TO: Mercedes-Benz Dealer Principals, General Managers, Sales Managers, Service Managers, Parts Managers	FROM: Gregory Gunther, Department Manager, Vehicle Compliance and Analysis, Engineering Services
RE: Service Campaign Launch Notification Retrofit Damping on Front Axle and Replace Engine Lining MY22 EQS-Class (297 platform)	DATE: May 27, 2022

Campaign No. 2022050012, May 2022

SUBJECT: **Model EQS-Class (297 platform)**
Model Year 2022

Retrofit Damping on Front Axle and Replace Engine Lining

Figure 1

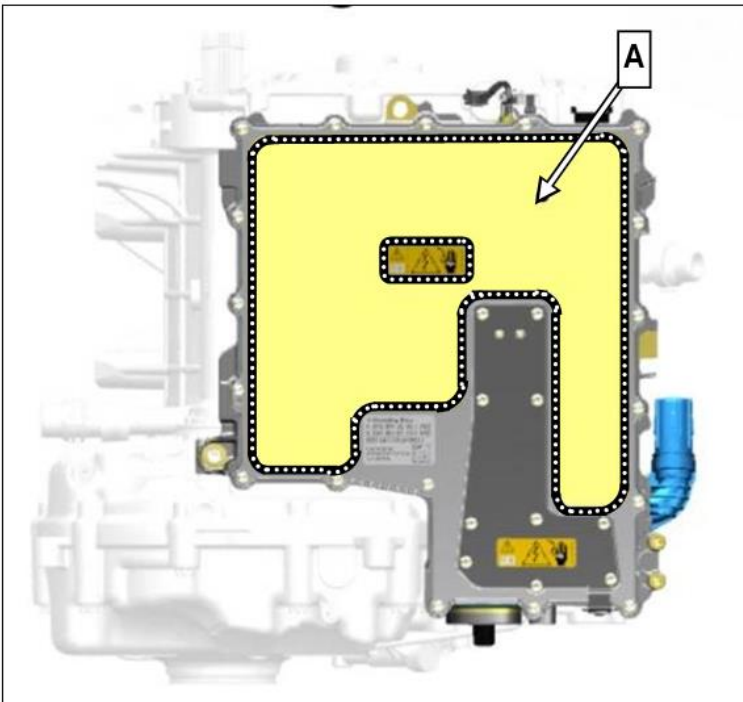
1. Perform power disconnect of high-voltage on-board electrical system.
i For basic data, see AR47.70-P-1000EQS.
2. Remove rear engine compartment cover (**B, Figure 2**).
i For basic data, see AR61.20-P-1105EQS.
3. Retrofit damping (**A, Figure 1**) in area of power electronics control unit (N147/4) on front axle drive module.
i Before installing the damping, the surface of the power electronics on the front axle drive module must be cleaned.
4. Replace rear engine compartment cover (**B, Figure 2**).
